H. B. ROBINSON STEAM ELECTRIC PLANT UNIT NO.
DOCKET NO. 50-261
FACILITY OPERATING LICENSE NO. DPR-23
REACTOR VESSEL OVERPRESSURIZATION

Responses to NRC Additional Information Request
of January 10, 1977

ans. Reference: FSAR, Section 4, Reactor Coolant System, Figure 4.2-1.

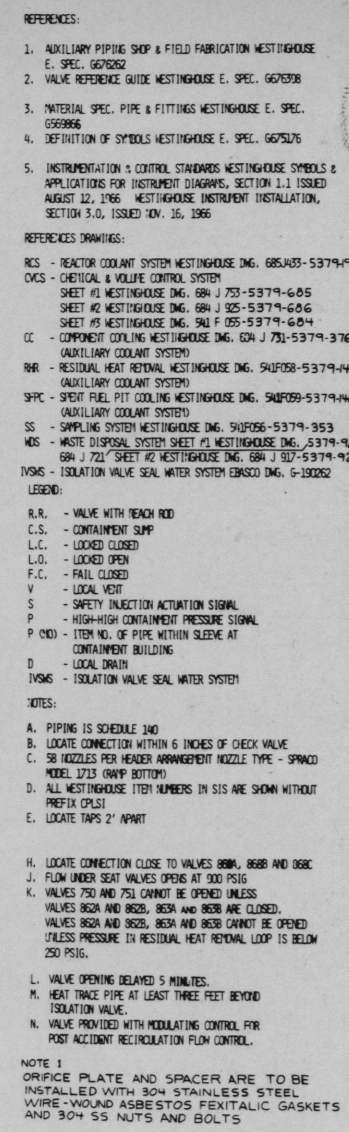
- e. Provide the necessary schematics and procedural descriptions that show what your actions would be to bring the RCS to an isothermal condition.

The RHR system is normally in operation and circulating the RCS prior to the starting of a RCP in a solid condition. The referenced figure locates the RHR system interface with the RCS loops. Flow is directed from the "B" loop hot leg through the RHR system and returned to loop cold leg via the low head SIS connection. Normal operating procedures and startup practices dictate that this circulation be in progress long before the first pump is started.

In addition to the above flow path, a relatively small flow is maintained to the loops by the CVCS. A small letdown is maintained from the RHR system into the CVCS for RCS pressure control. This flow (generally greater than 50 gpm) is returned to the RCS through the RCP thermal barrier and through the normal charging penetration in the "A" loop hot leg. The flow through the RCP thermal barrier is in-service since it accompanies the seal water injection flow which is required for RCP operation.

Since the above system configurations are routinely maintained during normal solid water conditions prior to starting a RCP, no procedures are provided that explicitly address a thermal profile. The procedures requiring these configurations are sufficient to create an equilibrium situation which approaches an isothermal condition.

SAFETY INJECTION PUMP PERFORMANCE CHARACTERISTICS

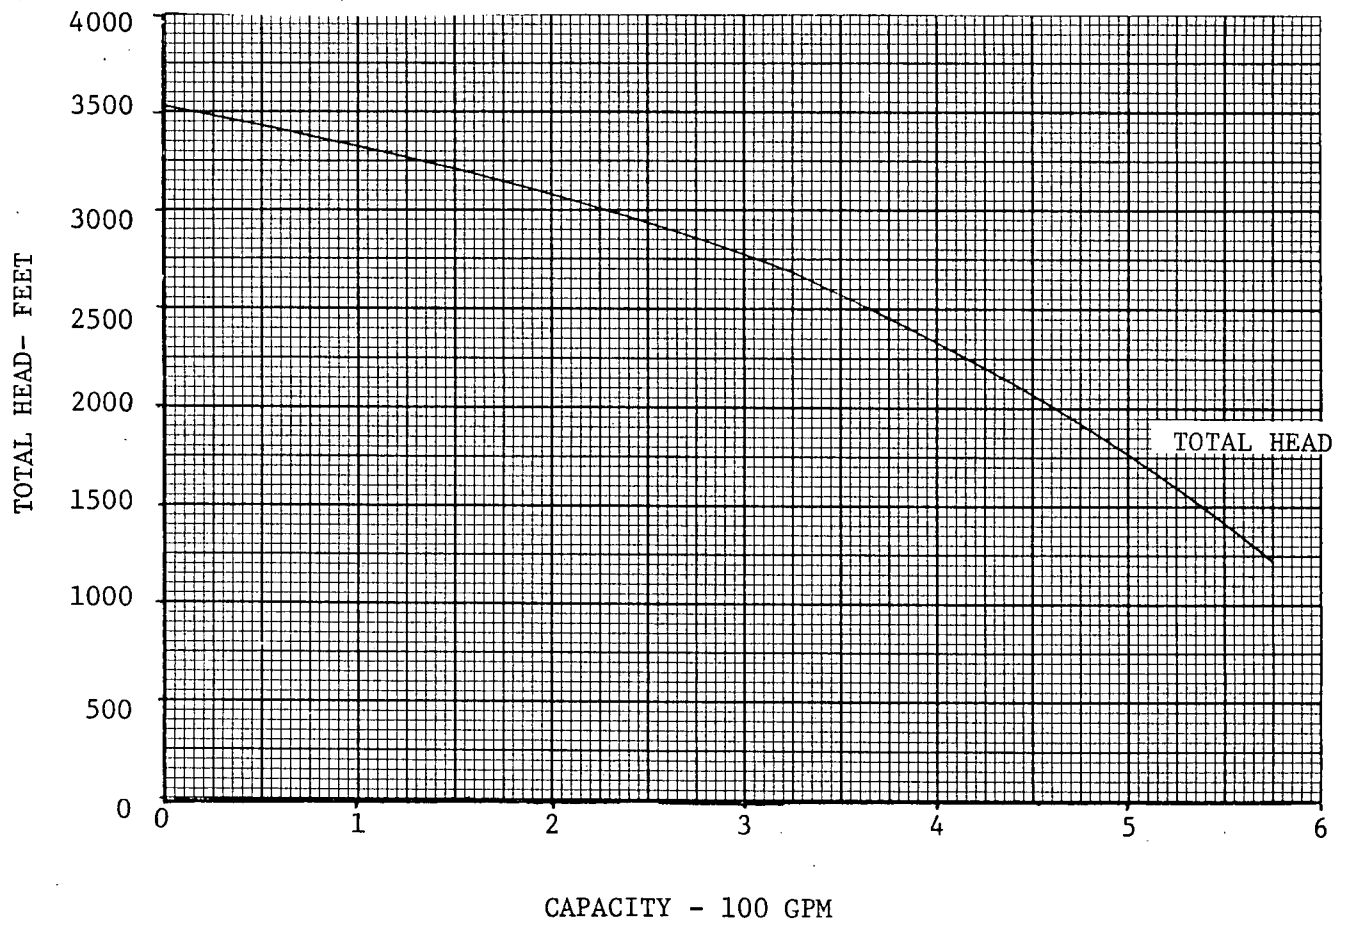
- b. The head-flow characteristics of each of the SIS pumps.

ans. This curve is attached.
